NUMBER: 18-053-15 REV. A

Malfunction Indicator Lamp (MIL) Illumination P0344 - Camshaft Position Sensor Intermittent

2012 - 2015 (JK)

Jeep Wrangler (RHD)

Fig. 1 Underhood Engine View

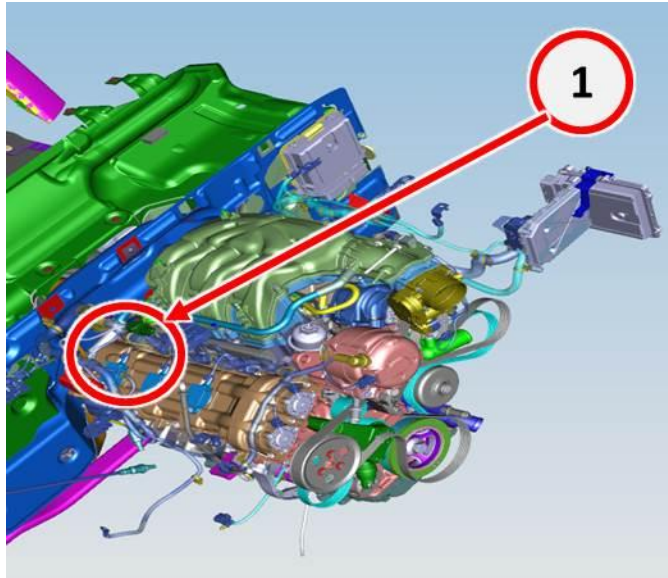
1. Remove the engine cover.
2. Locate the engine wire harness tower clip on the right side of the engine near the camshaft position sensor. See (Fig. 1).

Fig. 2 Engine Wire Harness

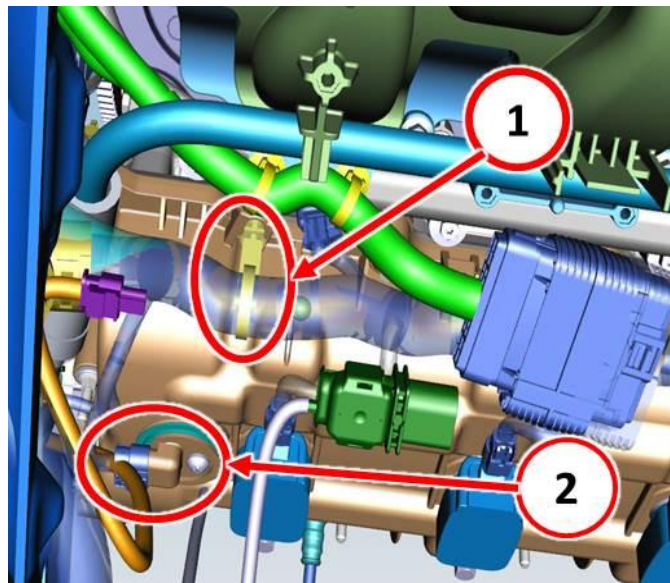
-
3. Remove the existing wire harness tower clip and install P/N 68289129AA tower clip in the same location on the wire harness. See (Fig. 2). Engage the tower clip to the cylinder head cover. The new tower clip should be a tighter fit to the cylinder head cover than the removed clip.

Fig. 3 CMP Sensor Connector

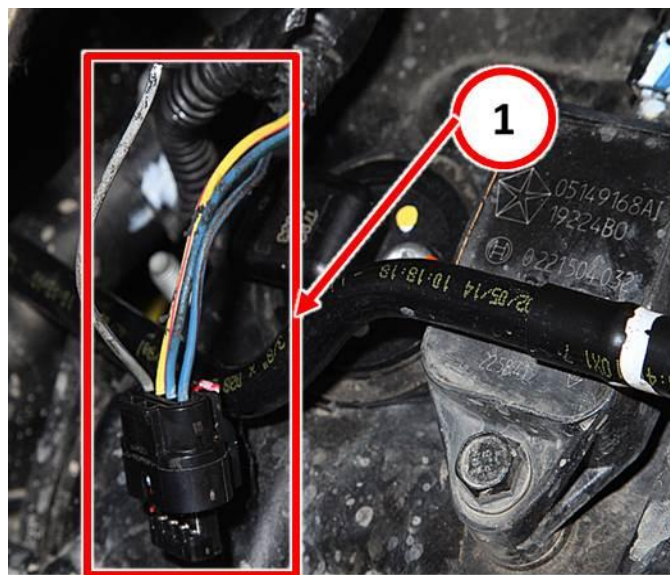
-
4. Repair any damaged wiring to the CMP harness near the connector. See (Fig. 3). Refer to detailed repair instructions in DealerConnect/TechConnect Service Information Section 29 - Non-DTC Diagnostics> Circuit Testing Procedures> Standard Procedure> WIRE SPLICING.
